APPAHD CONST 10-23-98 - Jan 99

**Re:** Alternative Pedestrian Light Pole  
footings for Arapaho Streetscape  
Project

Re: Arapaho Rd - Pedestrian Light Bases

## Hydraulic Capacity of "Y" Inlet

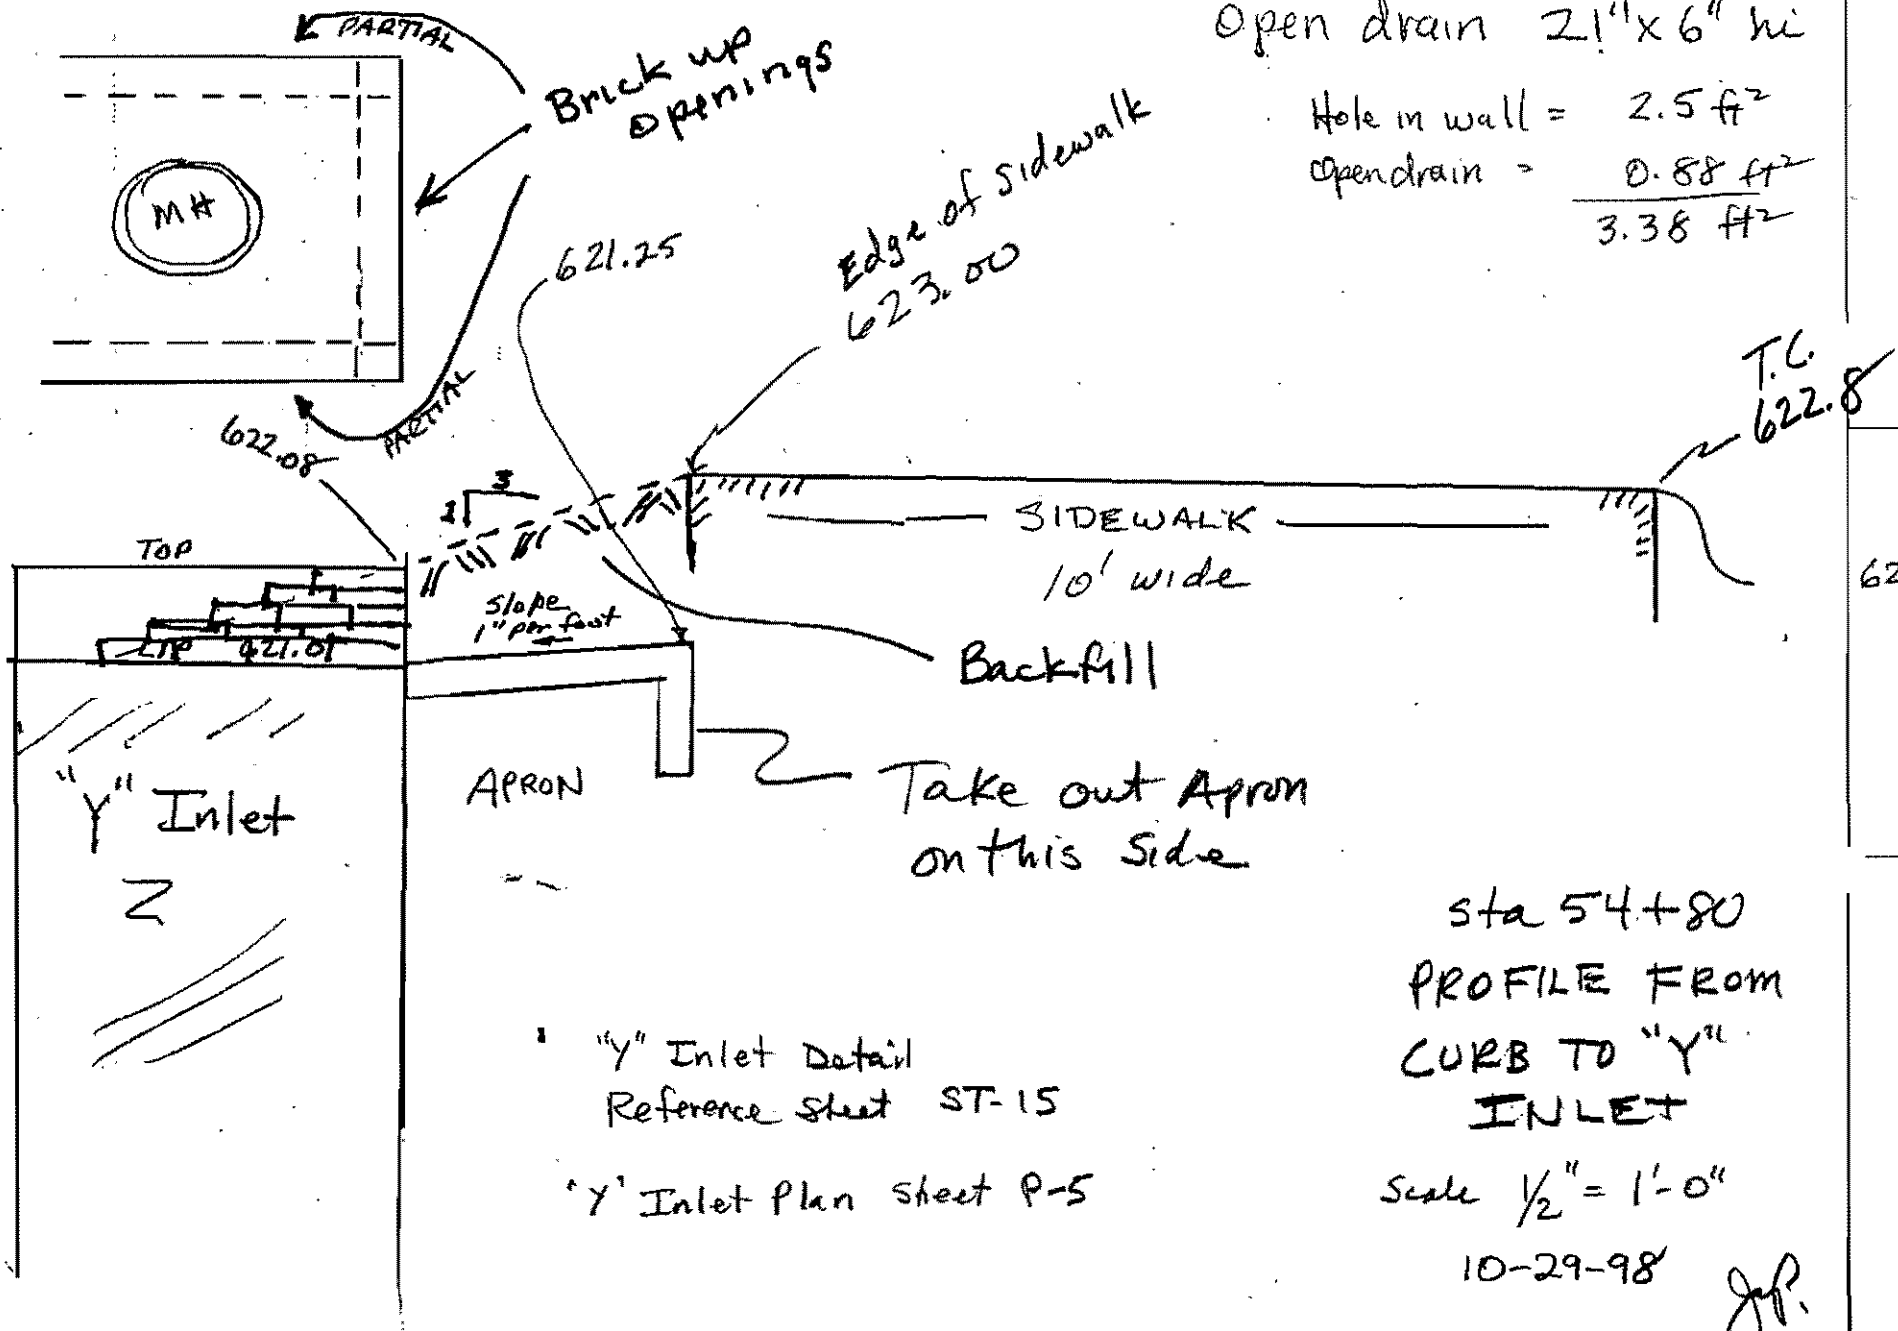
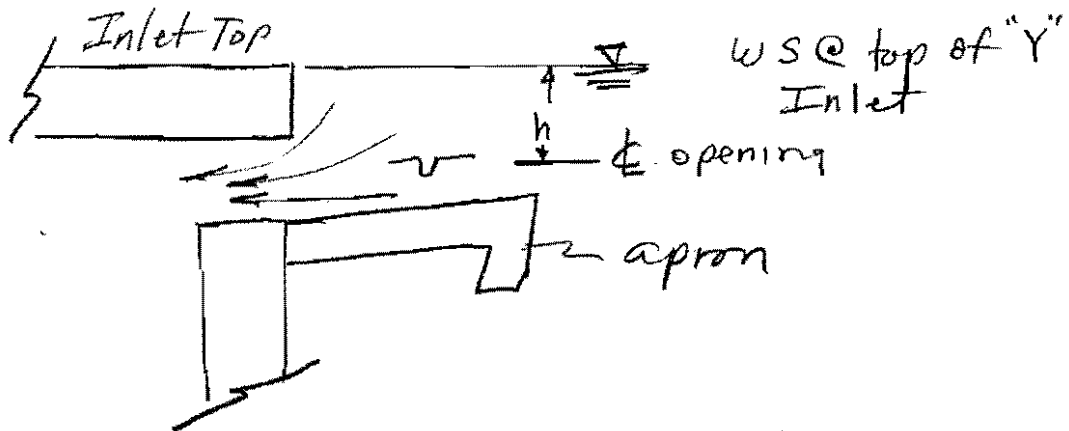
Comments: The flow to this inlet is  
9.99 cfs (from drainage map). The drawing  
shows what we want to do - block  
off some of the opening(s) and fill  
in between the inlet & sidewalk.

The calculations are my rough estimate  
of the capacity of the Y inlet with just  
one full side open. 2 other sides would  
add a little more capacity. Based on  
my calcs, the water would not exceed  
the elevation of the top of the inlet &  
probably would be less.

sta 54+80  
 PROFILE FROM  
 CURB TO "Y"  
 INLET  
 Scale 1/2" = 1'-0"  
 10-29-98  
 J.P.

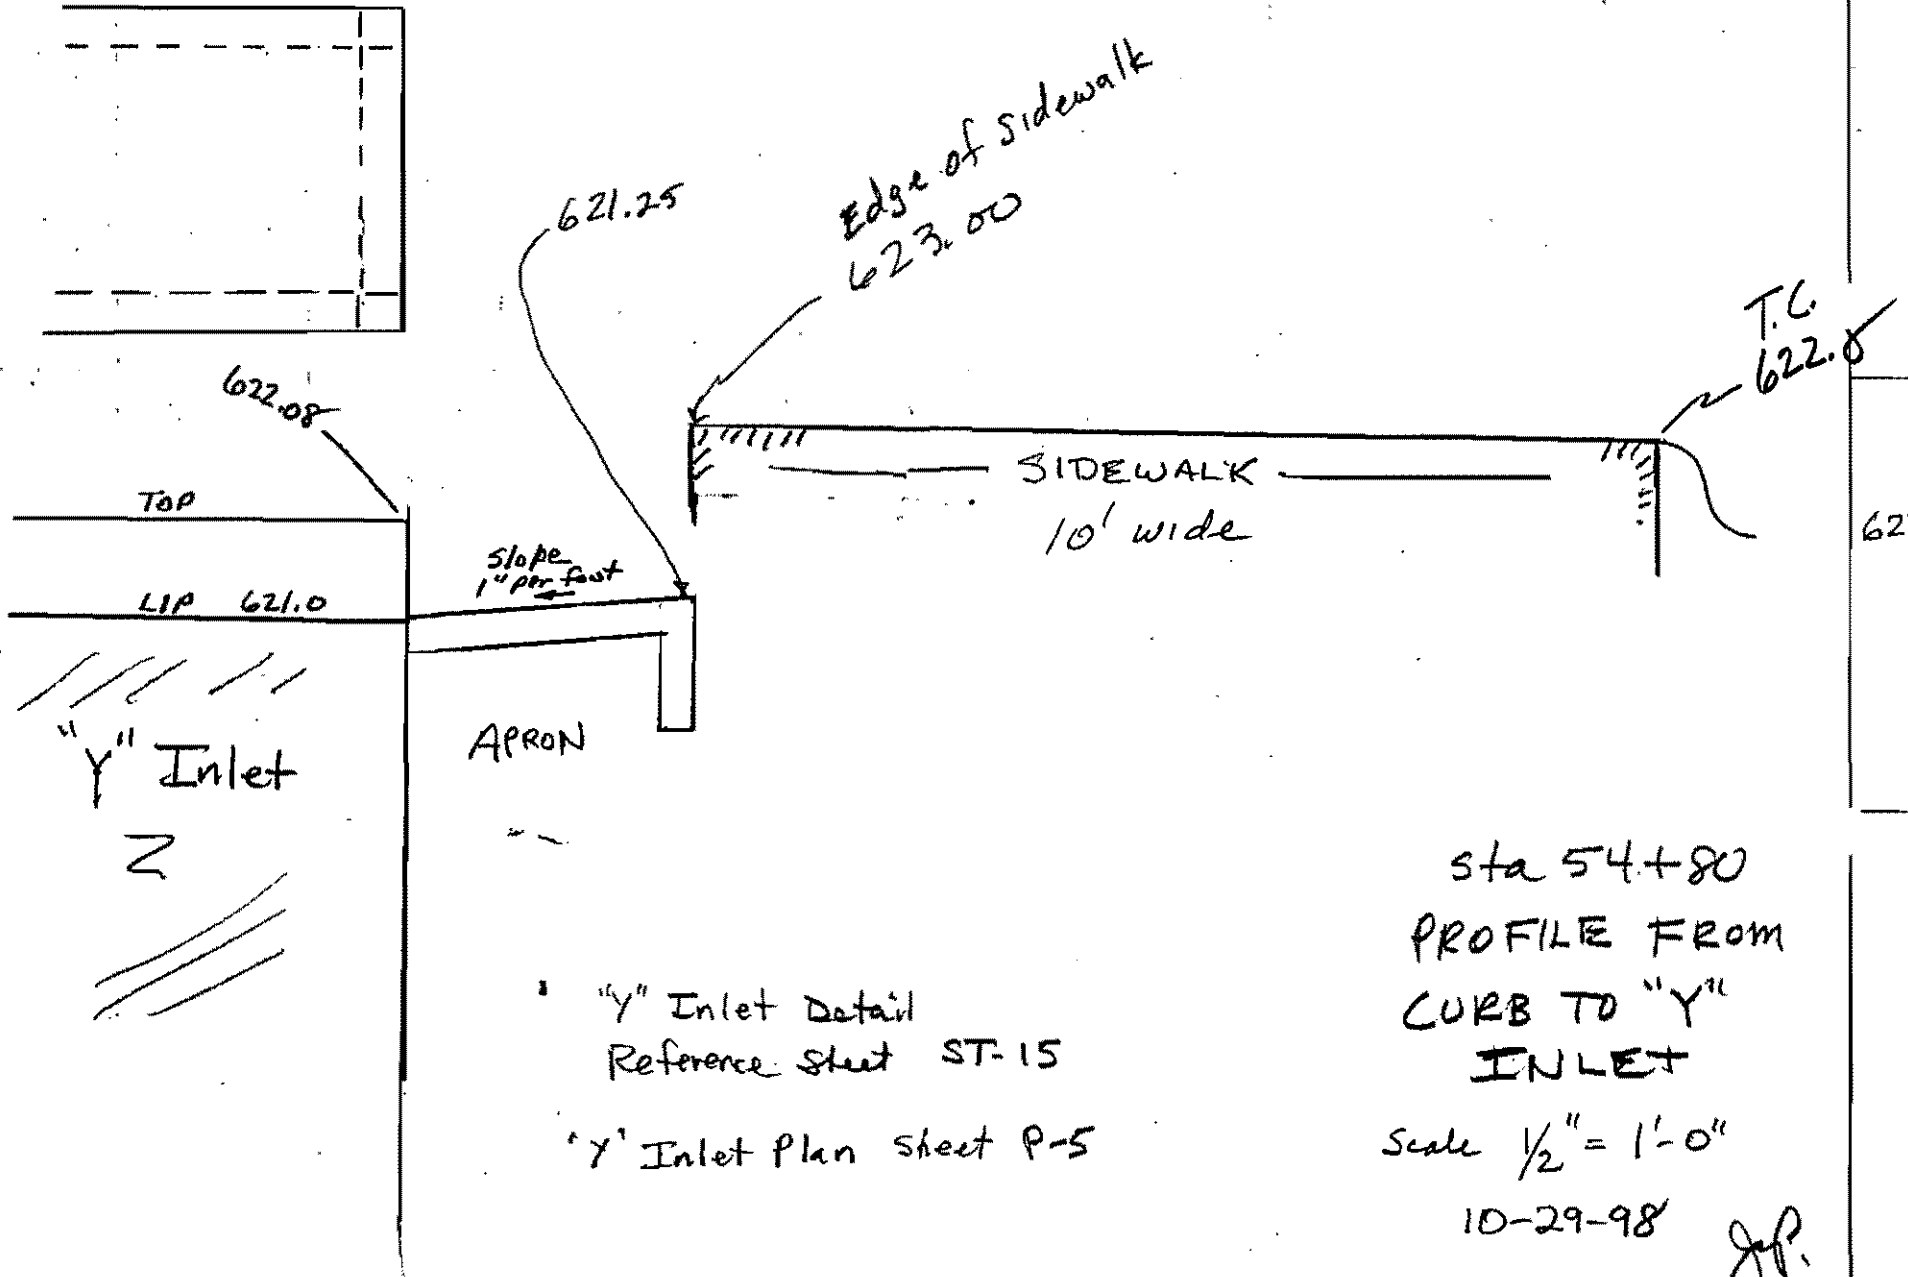
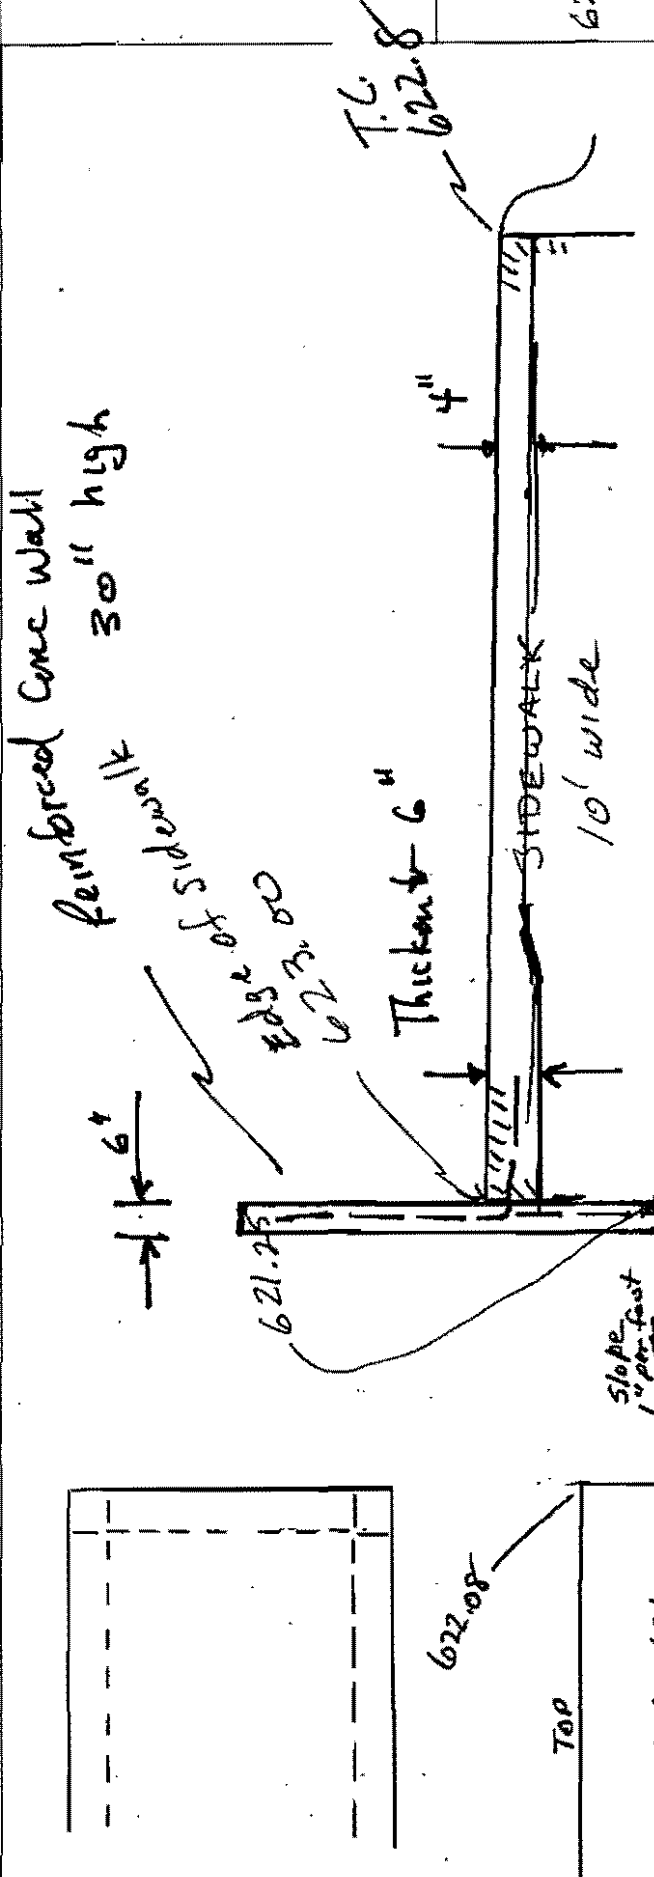
Comments: attached sketch shows a  
"drop-off" problem @ "Y" inlet.
